I-85 SEWER EXTENSION  
CONTRACT 1B – COLLECTIONS

ADDENDUM NO. 6

January 10, 2024

Gaffney Board of Public Works  
I-85 Sewer Extension  
Contract 1B- Collections Broad River  
WWTP to Bear Den SPS

C-02-111A

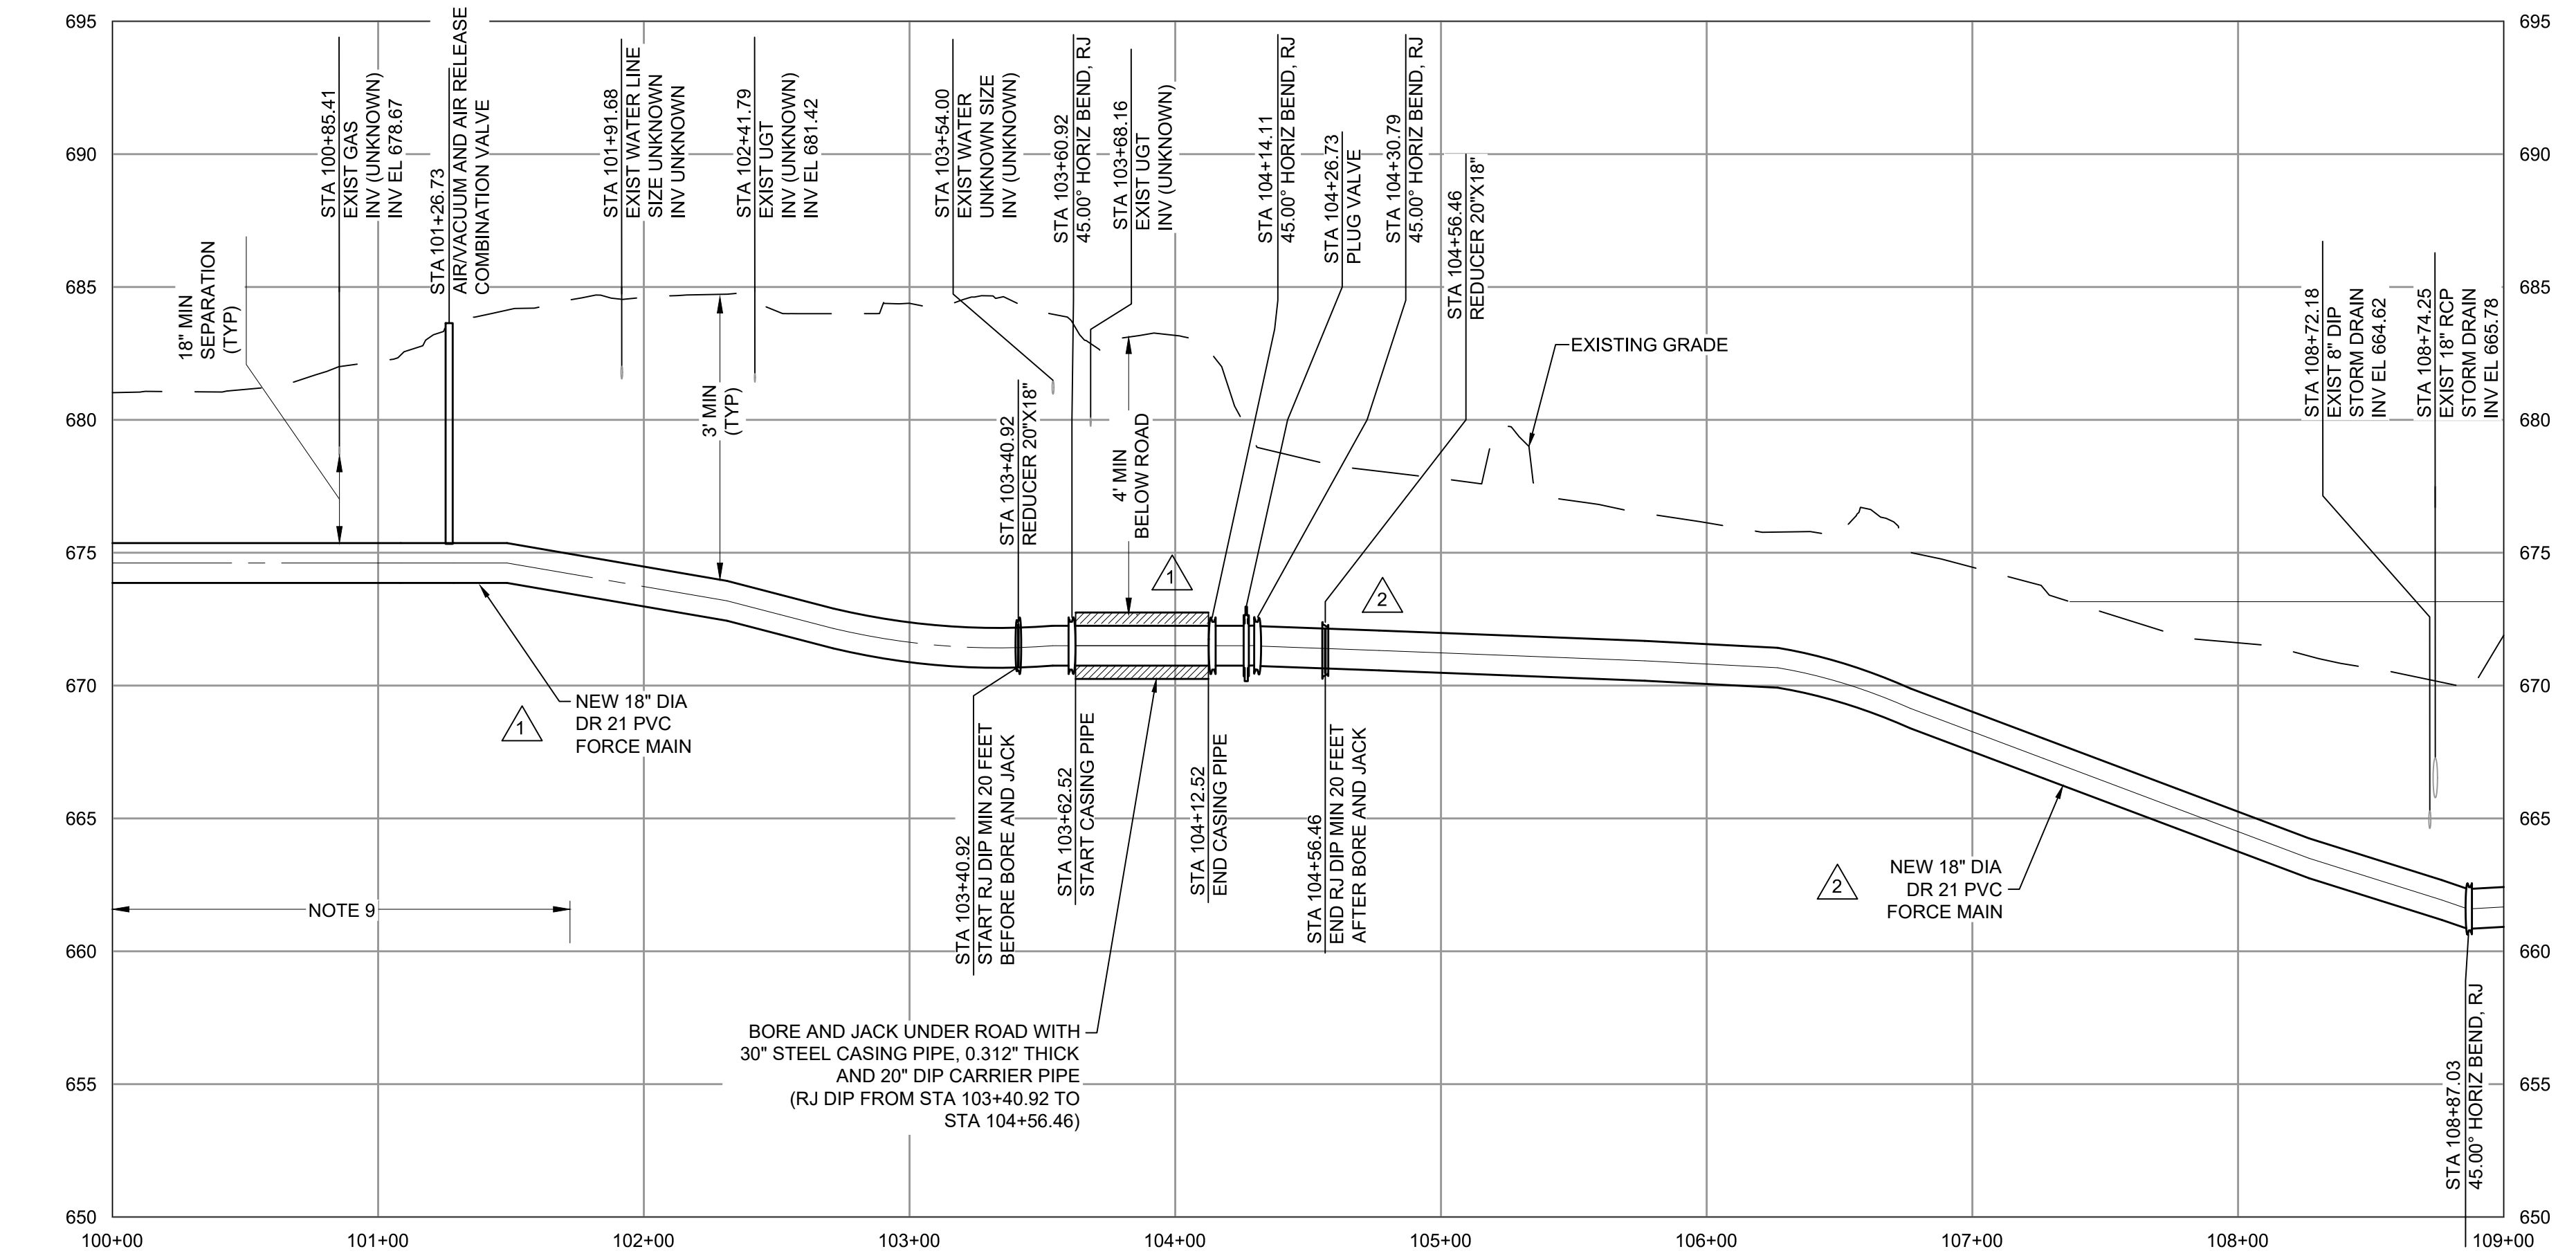
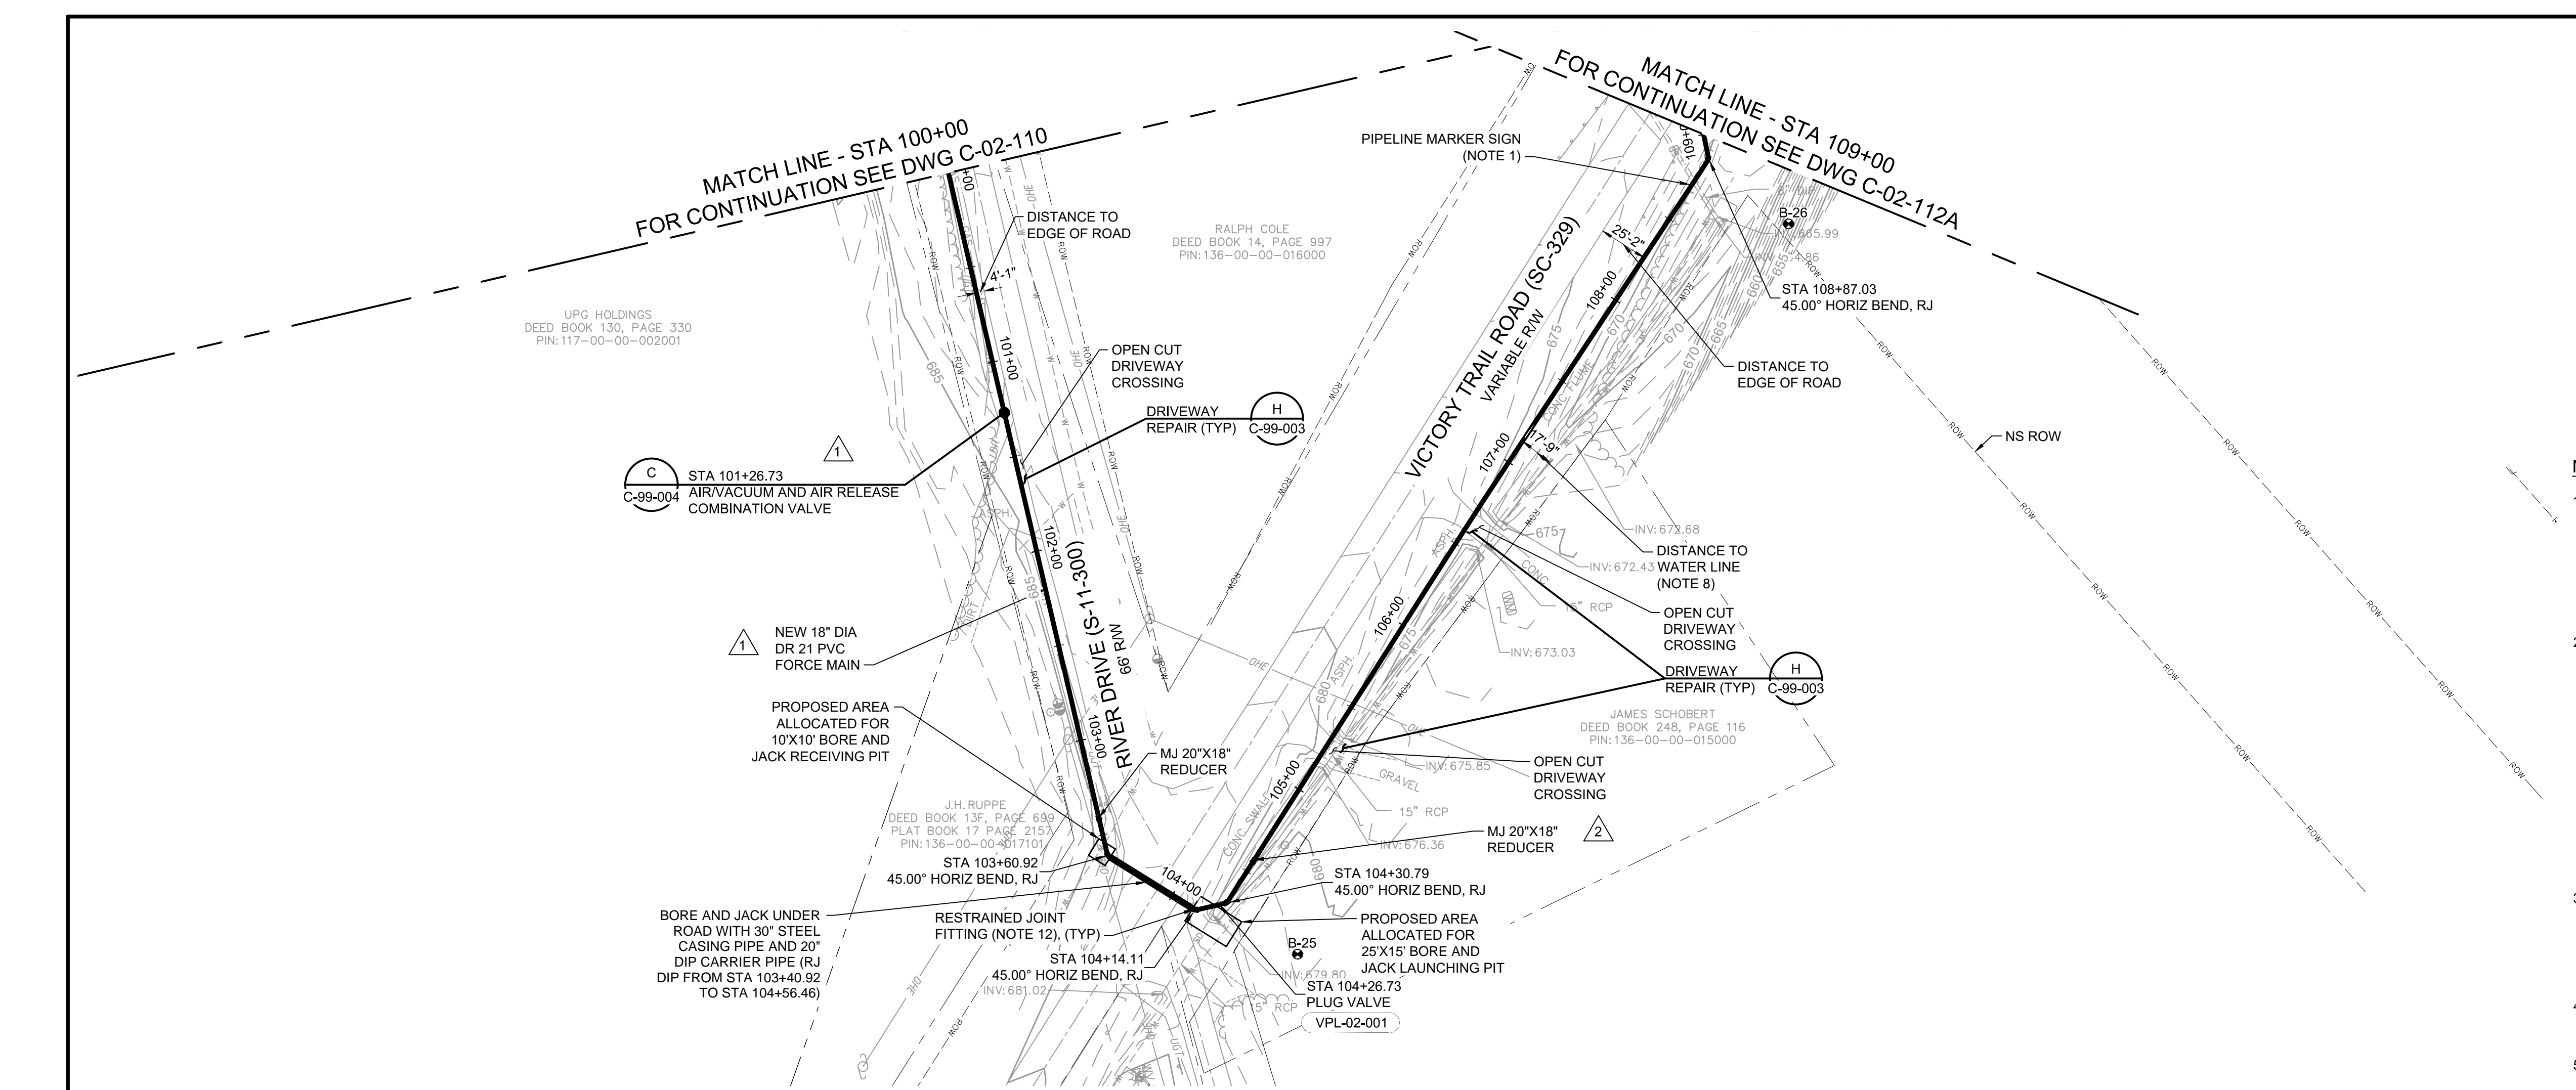
Alternative 1: Removal of Segment 2 horizontal directional drilling and 24” DR 11 HDPE force main under the railroad along Victory Trail Road (Hwy 329). Installation of 18” DR 21 PVC force main with an 18” DIP, RJ Class 250 pipe hanging along the Highway 329 bridge over the railroad.

Remove Segment 2 horizontal directional drilling and 24" DR 11 HDPE force main under the railroad along Victory Trail Road (Hwy 329). Install 18" DR 21 PVC force main with an 18" DIP, RJ Class 250 pipe

hanging along the Highway 329 bridge over the railroad.

- i. Insert the attached new sheets C-02-111A and C-02-112A for Segment 2 Alternative 1 and the new sheets C-03-114A and C-03-115A for Segment 3 Alternative 2 after sheet C-03-120.
- ii. Insert the attached new sheets S-00-001, S-01-101A, and S-01-102A for the Alternatives after sheet C-99-006.
